**REZONING &
SUBDIVISION STAFF REPORT**

Date: January 8, 2004

Murphy's Transmission Subdivision

Subdivision: 1515 St. Stephens Road
(Southeast corner of St. Stephens Road and North Catherine Street)

SITE PLAN

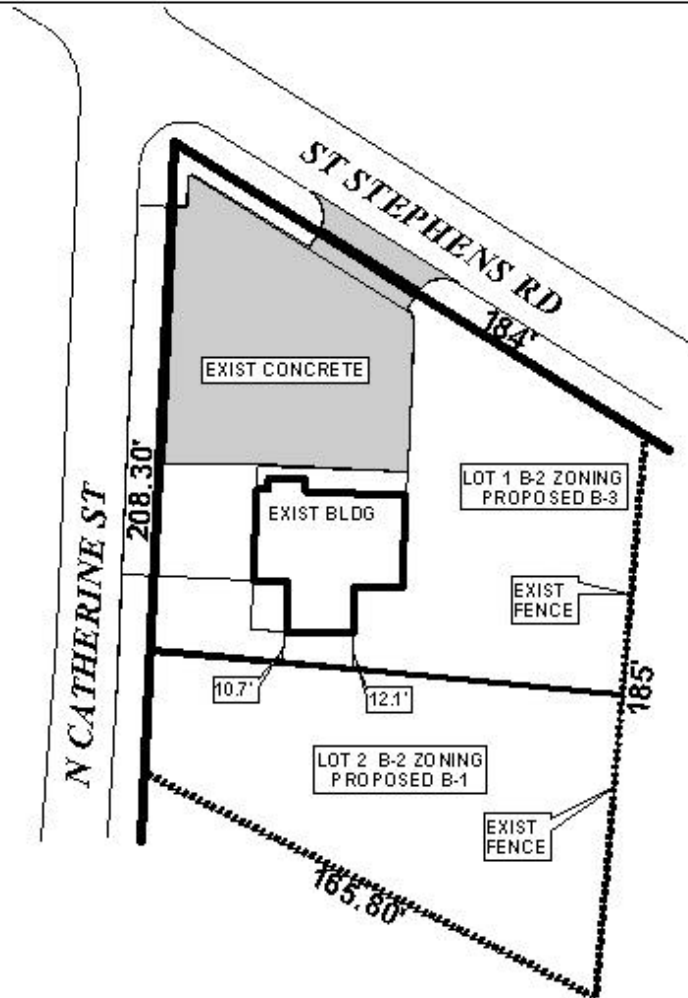
While there has been some degree of compliance, it does not appear that the site is in full compliance with the Variance conditions or requirements of the Zoning Ordinance. The outside work area is not enclosed with a 6' privacy fence (or other screening); much of the outside work area/parking is not paved (a requirement of the Zoning Ordinance); and it does not appear that the site is in full compliance with the landscaping and tree planting requirements – and still may not be if subdivided into two lots.

In addition, St. Stephens Road has been added to the Major Street Plan in place of Congress Street. Therefore, dedications of sufficient right-of-way to provide 50' from the centerline of St. Stephens Road and an appropriate radius at the intersection of St. Stephens Road and Catherine Street would be appropriate. And, as a method of access management, elimination of the continuous curb cut(s) should be required – with new cut(s) to be approved by the Traffic Engineering Department.

Rezoning: B-3 - based on the preceding, it is recommended that this application be approved subject to the following conditions: 1) dedication of sufficient right-of-way along St. Stephens Road to provide 50' from centerline; 2) dedication of an appropriate radius at the intersection of St. Stephens Road and North Catherine Street; 3) elimination of the continuous curb cuts, including installation of curbing and landscaping, with new cuts to be approved by Traffic Engineering; 4) completion of the Subdivision Process prior to the issuance of any permits; 5) all parking areas to be paved; 6) vehicles to be screened from view, as required by the Zoning Ordinance; 7) the site be brought into full compliance with the landscaping and tree planting requirements of the Zoning Ordinance; and 8) full compliance with all municipal codes and ordinances.

Subdivision: with modifications, the plat meets the minimum requirements of the Subdivision Regulations subject to the following conditions: 1) dedication of sufficient right-of-way along St. Stephens Road to provide 50' from centerline; 2) dedication of an appropriate radius at the intersection of St. Stephens Road and North Catherine Street; 3) elimination of the continuous curb cuts, including installation of curbing and landscaping; and 4) placement of a note on the final plat stating that curb cuts are to be approved by the Traffic Engineering Department.
